<b>Date</b>	05 Apr 2011		<b>Release Note #</b>	4300-1003	<b>ECO Ref #</b>	0847
<b>Product</b>	4300		<b>Description</b>	3-Way Distributor		
<b>Revision Change</b>	<b>From</b>	F	<b>To</b>	G	<b>Created By</b>	Joey Yangco

<b>Assembly / Part #</b>	2800-0127 Rev. G/ 3250-0041 Rev. G
<b>Serial #</b>	SP02504 or later
<b>Description</b>	Replace the 3-way syringe pump distributor from 3 pieces to one piece design.

**Existing 3-Way Diverter**

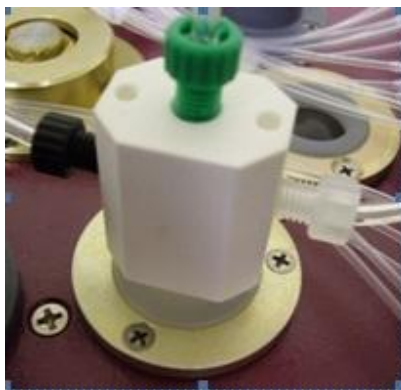
This part was redesigned to incorporate all 3 existing parts (3-way diverter, adapter and aluminum piece) into a one piece design to simplify the assembly and increase reliability.

For older models using flat head screws to secure the 3-way distributor, three 4/40 x 0.375 inch long socket head screws will be required for replacement.

When using the one piece 3-way diverter on existing instruments, be aware to position the diverter in a way that you can access all the fittings without any inference from the adjoining diverters and the top cover.
